EC70139 REV. 0  
ATTACHMENT Z48R0  
DWG. NO. 522-041-006

|  <b>NUCLEAR ENGINEERING</b><br>CRYSTAL RIVER UNIT 3<br>AUXILIARY BUILDING - SOUTH STEEL FRAMING MODIFICATIONS DETAILS |       |             |         |       |      |

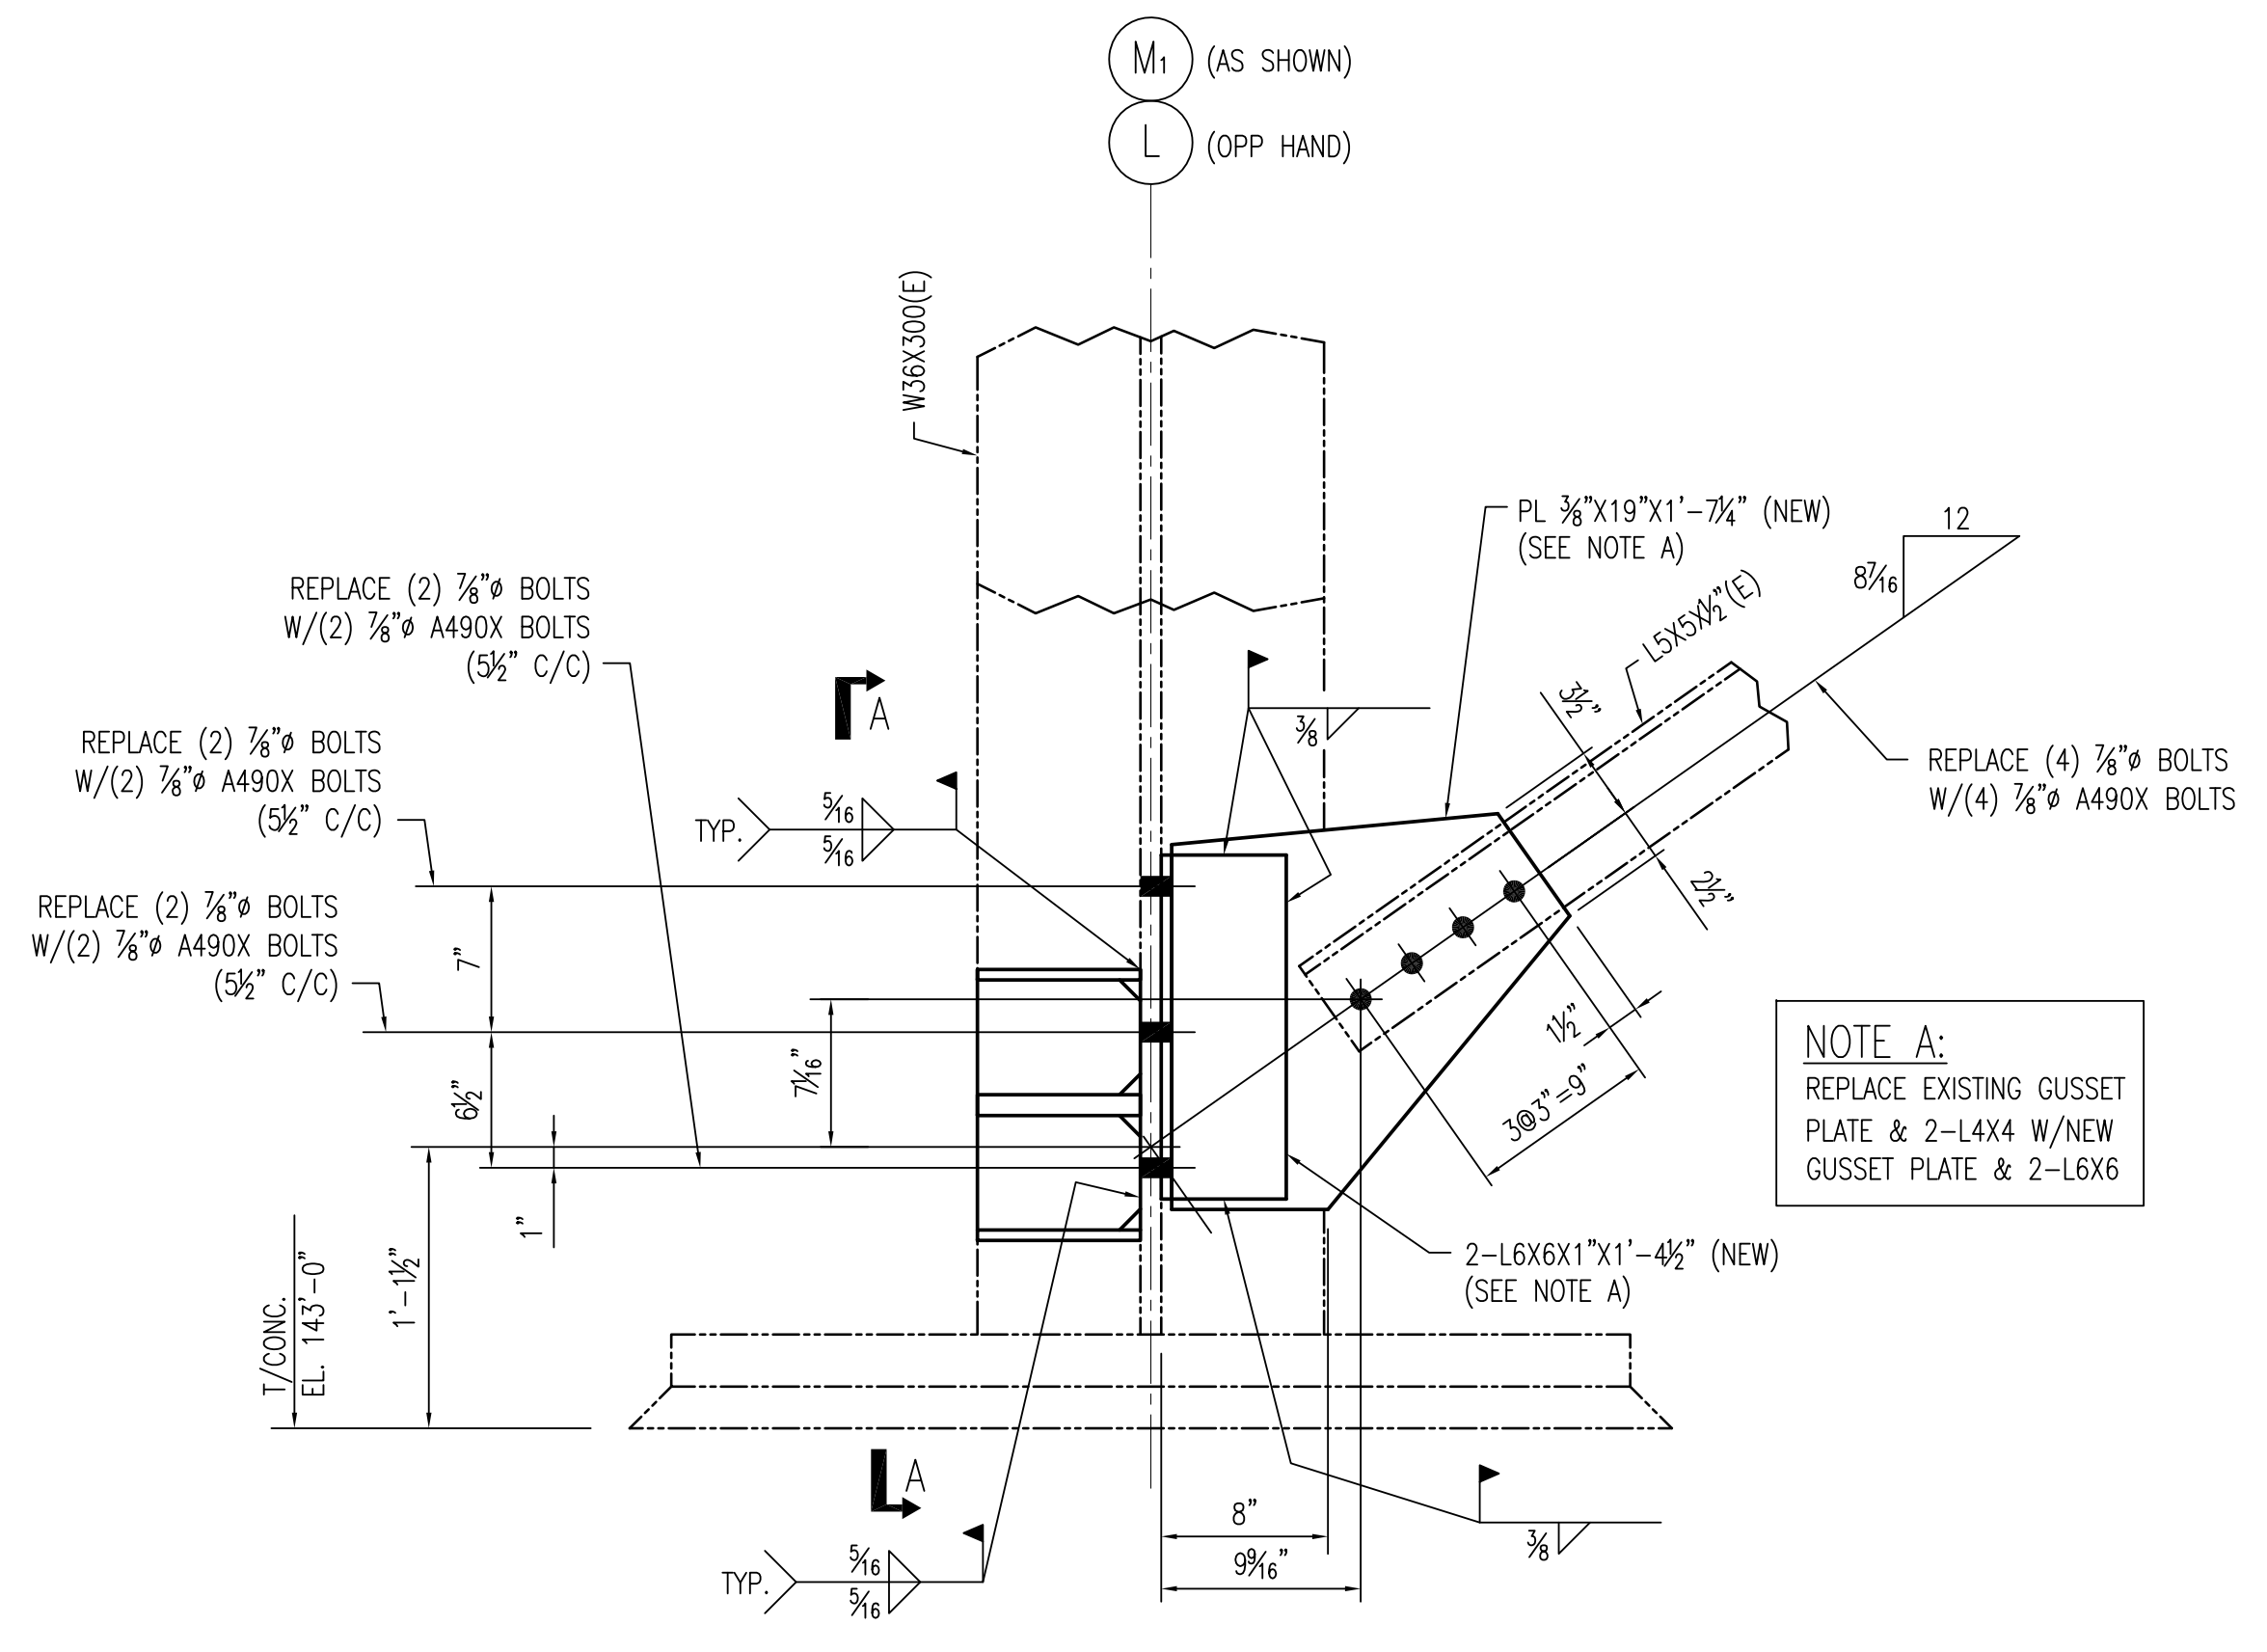
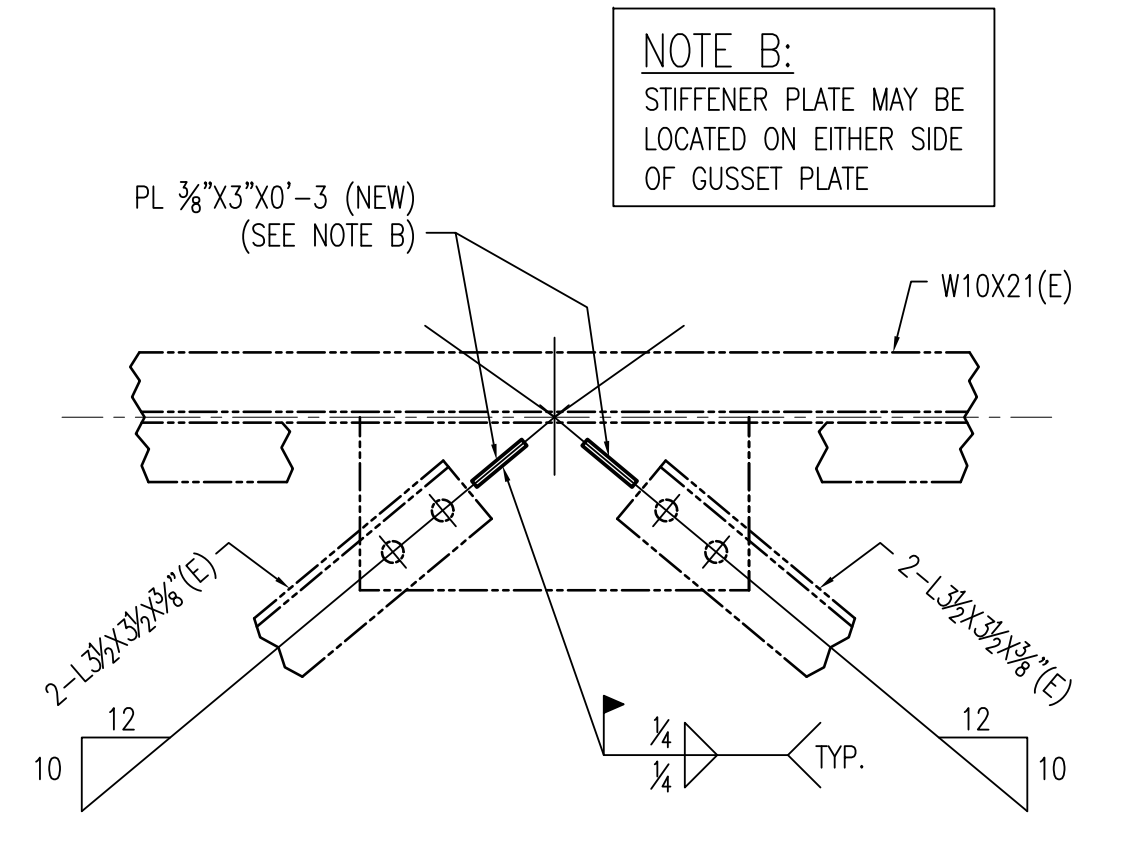
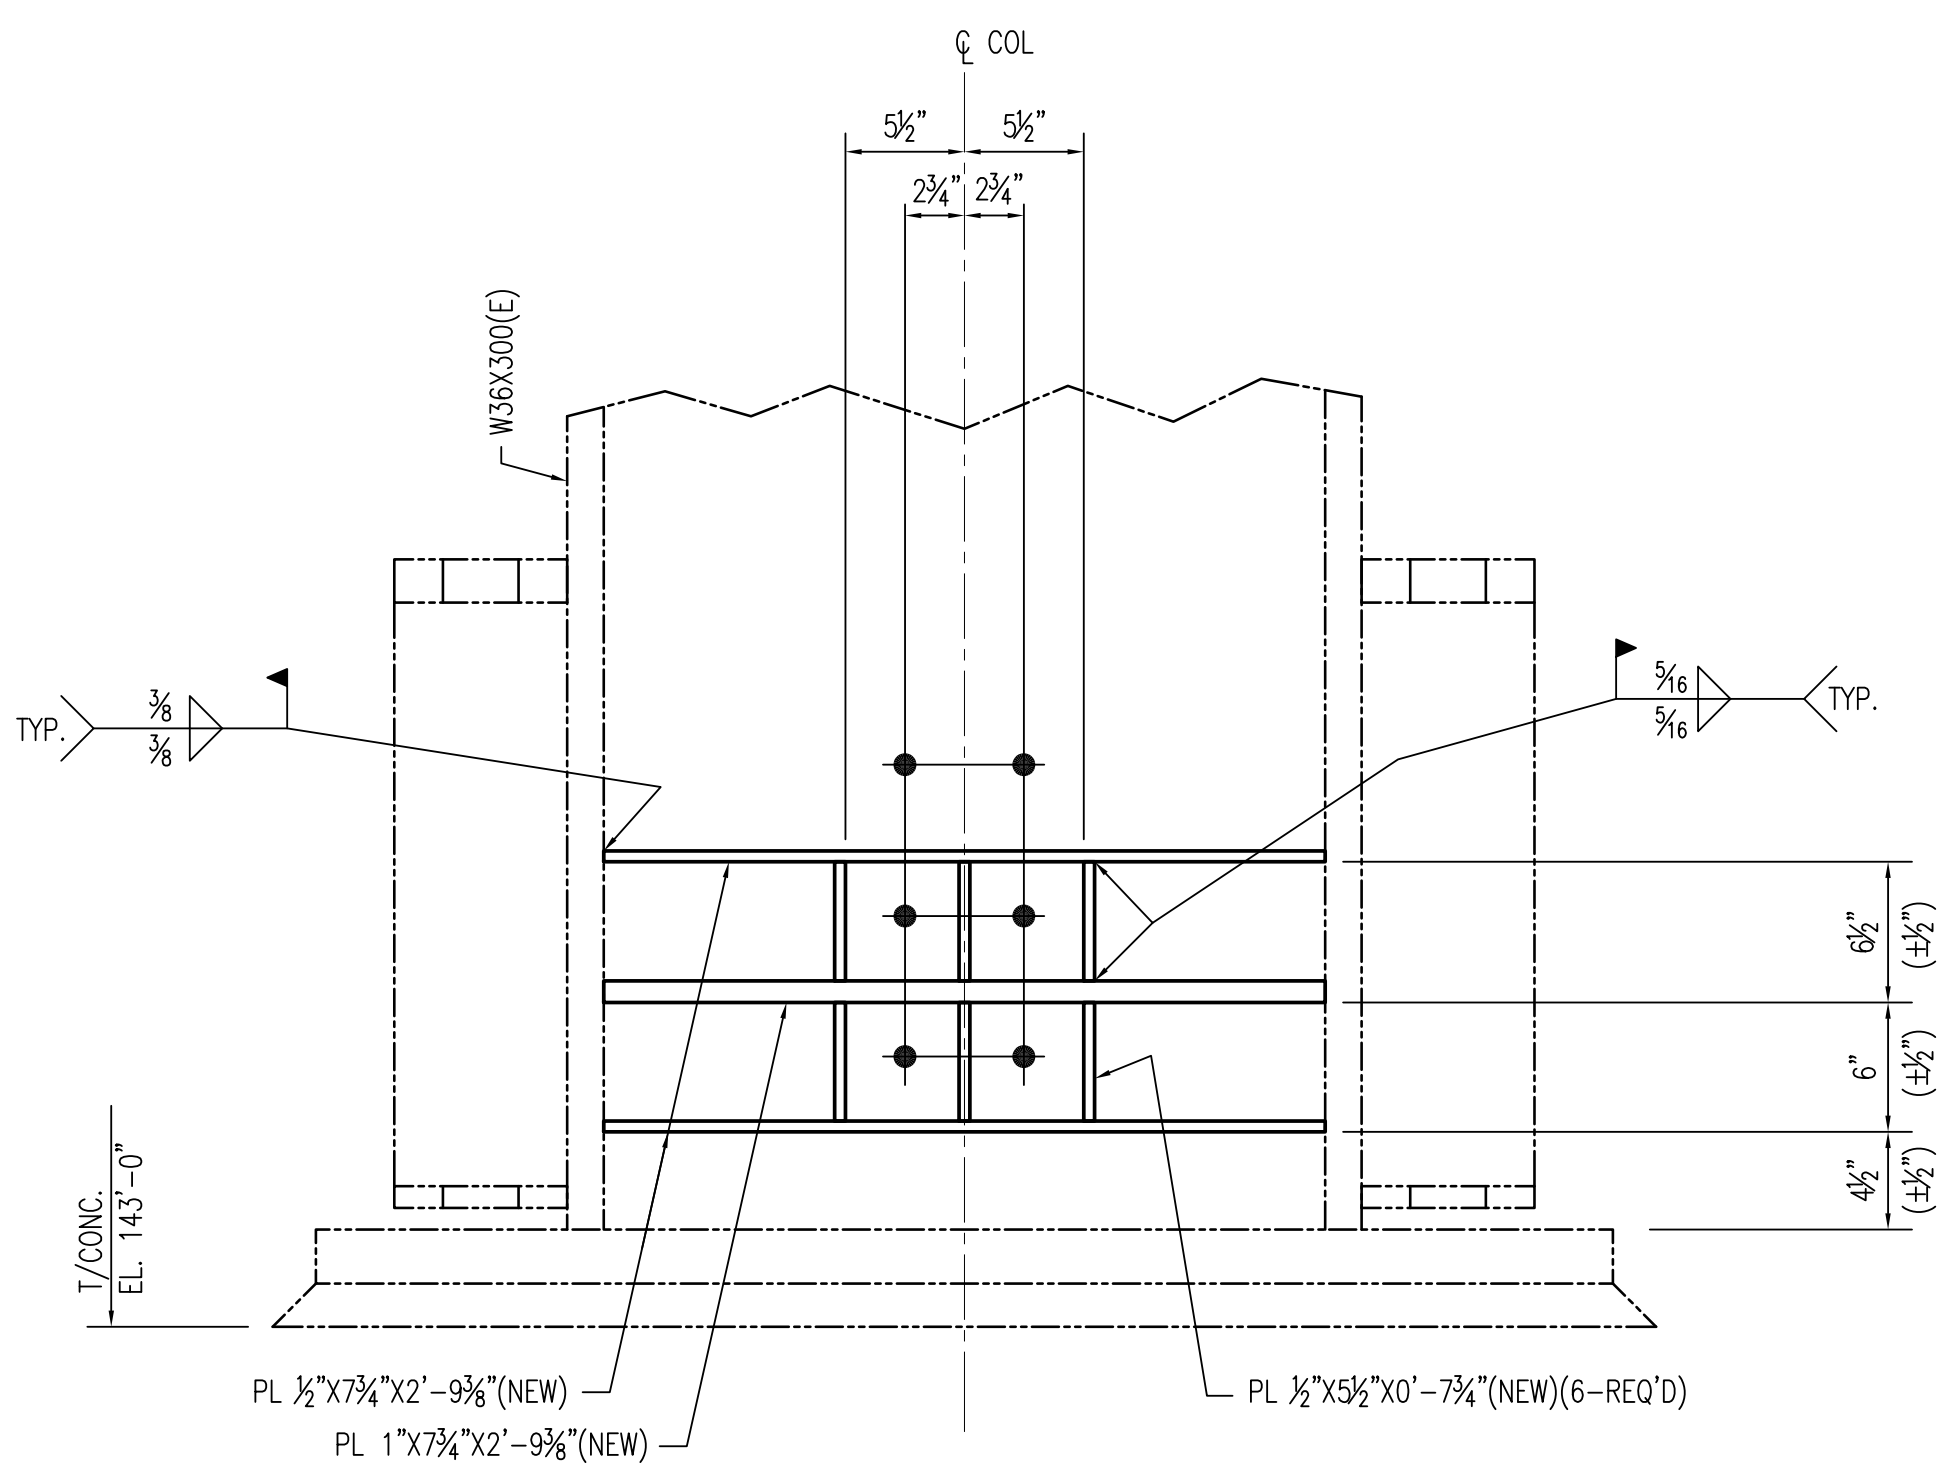
NOTE A:  
REPLACE EXISTING GUSSET PLATE & 2-L4X4 W/NEW GUSSET PLATE & 2-L6X6

NOTE B:  
STIFFENER PLATE MAY BE LOCATED ON EITHER SIDE OF GUSSET PLATE
